Reply to Office Action of April 25, 2006

Docket No.: 0142-0416P

AMENDMENTS TO THE DRAWINGS

REMARKS

FIG. 1

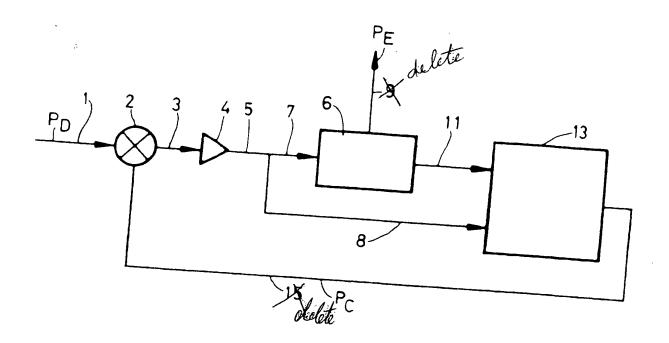
The attached sheet(s) of drawings includes changes to Figure 1 and Figure 4B. Please correct figure 1 by eliminating numeral 9 and numeral 15. Also correct, figure 4B by changing capital P sub capital F, to capital P sub capital E.

Action letter. As the Examiner will note, figure 1 has been amended to eliminate elements 9 and 15

FIG. 4A

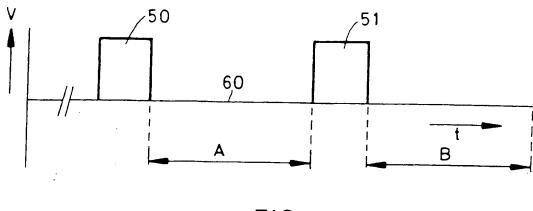
which were deemed unnecessary and figure 4B has been amended to correct "PF" to "PE". Accordingly,
